United Nations Global Technical Regulation on the measurement procedure for two- ~~and three~~-wheeled ~~motorcycles~~ vehicles equipped with a positive or compression ignition engine with regard to the emissions of gaseous pollutants, CO2 emissions and fuel consumption

Draft Amendment 45

Submitted by the Informal Working Group on Environmental and Propulsion Performance Requirements (EPPR)*

Proposal for amendments to GTR No. 2 Amendment 4 are marked in track changes.

Figure A1/7
Flowchart for the number of type I tests

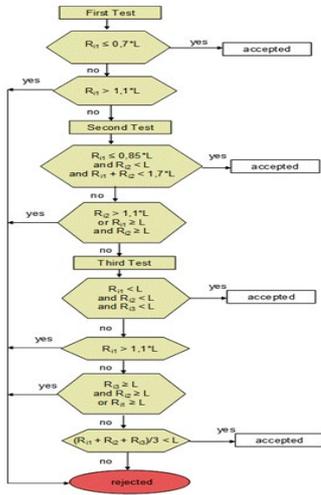
Commented [Sec.22]: to delete the old flowchart and to replace with new one, aligned with WLTP

Figure A4.App12/5

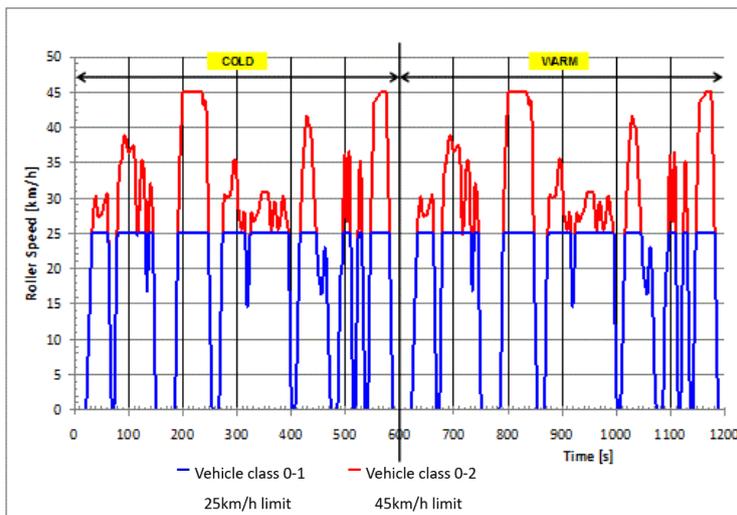
Commented [DL94]: changed

Note: ~~The blue line depicts RST25, i.e. the truncated desired-vehicle speed trace limited to 25 km/h, is applicable for vehicles with a limited-maximum design vehicle speed of 25 km/h of class 0-1.~~
